UNITED STATES PATENT AND TRADEMARK OFFICE

APPLICATION NO.	FILING DATE	FIRST NAMED INVENTOR	ATTORNEY DOCKET NO.	CONFIRMATION NO.
10/597,369	07/11/2008	Mitsuo Nagura	703409.4001	9950

Office Action Summary	Application No. 10/597,369	Applicant(s) NAGURA, MITSUO	
	Examiner ELIZABETH VOLZ	Art Unit 3781

DETAILED ACTION

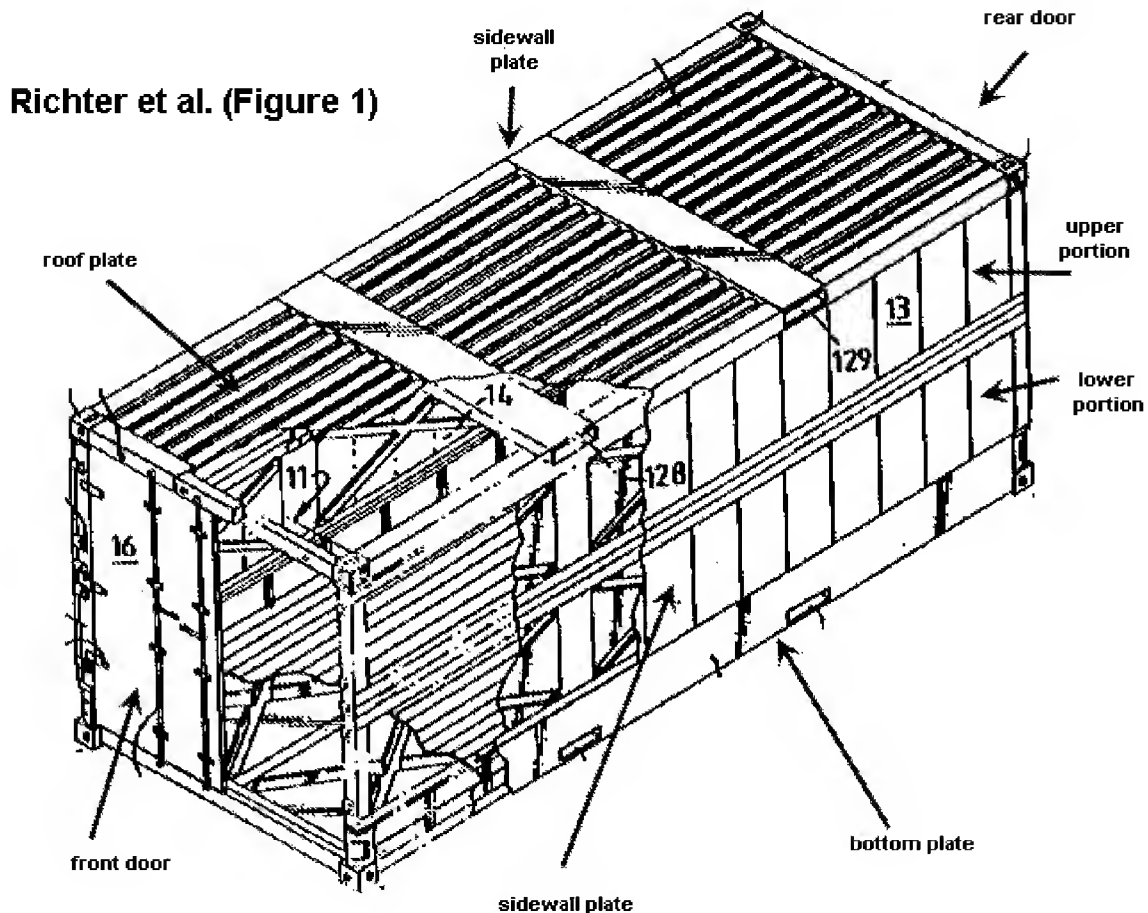
2. Claims 9-11 and 17 are rejected under 35 U.S.C. 102(b) as being anticipated by Richter et al. (U.S. Patent No. 5,190,179).

3. Regarding Claim 9, Richter et al. discloses a container comprising: a container main body having a roof plate (Figure 1 below) and a left/right pair of side wall plates (Figure 1 below); a bottom plate (Figure 1 below); and a front door (Figure 1 below) and a rear door (Figure 1 below) which respectively open and close a front end portion and a rear end portion of said container main body (Figure 1), wherein said container main body and said bottom plate are displaceable relative to each other in a front-rear direction of the bottom plate from a neutral reference position, in which said bottom plate is aligned with said container main body (Figure 1), and wherein said container main body and said bottom plate are displaceable relative to each other between a first exposed position, in which said container main body is positioned rearward of said bottom plate such that a front portion of said bottom plate is exposed from said container main body, and a second exposed position, in which said container main body is positioned forward of said bottom plate such that a rear portion of said bottom plate is exposed from said container main body (Examiner believes that since the bottom plate

is removable (Figure 3), the main body can be placed in front of the base as well as behind the base to read on the applicant's claim language).

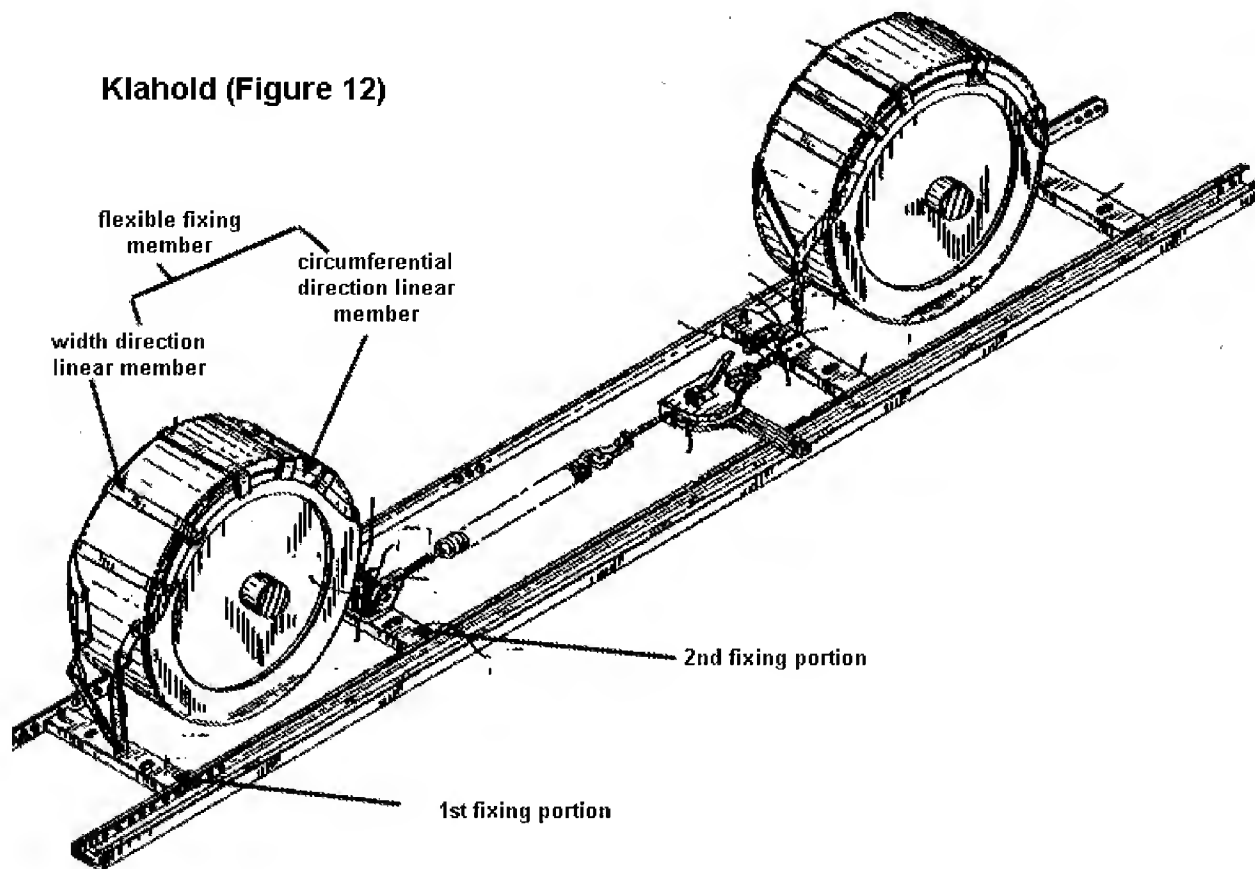
10. Regarding Claims 13-15 and 19-21, Richter et al. and Gonska teach all the limitations substantially as claimed except for a flexible fixing member having a pair of circumferential-direction linear members which are flexible, have a linear shape, and correspond to a circumferential direction of a tire of said automobile, and a width-direction linear member which is flexible, has a linear shape, connects said pair of circumferential-direction linear members, and corresponds to a width direction of said

tire; and a first fixing portion and a second fixing portion provided in relation to said bottom plate, a part of said circumferential-direction linear member on one side of a part which is disposed along at least an upper end portion of said tire being fixed to said first fixing portion, and a part of said circumferential-direction linear member on the other side of said part which is disposed along at least said upper end portion of said tire being fixed to said second fixing portion; wherein positions of said first fixing portion and said second fixing portion in said front-rear direction of said bottom plate are selectable and a tensioning member to tension the first and second fixing portion to the bottom plate. However, Klahold teaches a flexible fixing member having a pair of circumferential-direction linear members (Figure 12 below) which are flexible, have a linear shape, and correspond to a circumferential direction of a tire of said automobile (Figure 12), and a width-direction linear member (Figure 12 below) which is flexible, has a linear shape, connects said pair of circumferential-direction linear members (Figure 12), and corresponds to a width direction of said tire; and a first fixing portion (Figure 12 below) and a second fixing portion (Figure 12 below) provided in relation to said bottom plate, a part of said circumferential-direction linear member on one side of a part which is disposed along at least an upper end portion of said tire being fixed to said first fixing portion (Figure 12), and a part of said circumferential-direction linear member on the other side of said part which is disposed along at least said upper end portion of said tire being fixed to said second fixing portion; wherein positions of said first fixing portion and said second fixing portion in said front-rear direction of said bottom plate are selectable (Figure 12) and a tensioning member 130/132 (Figure 12) to tension the first

and second fixing portion to the bottom plate. Therefore, it would have been obvious for one of ordinary skill in the art to modify Richter et al. and Gonska to include a flexible fixing member, fixing members and tensioning members, as taught by Klahold, in order to prevent movement within the container when shipping.
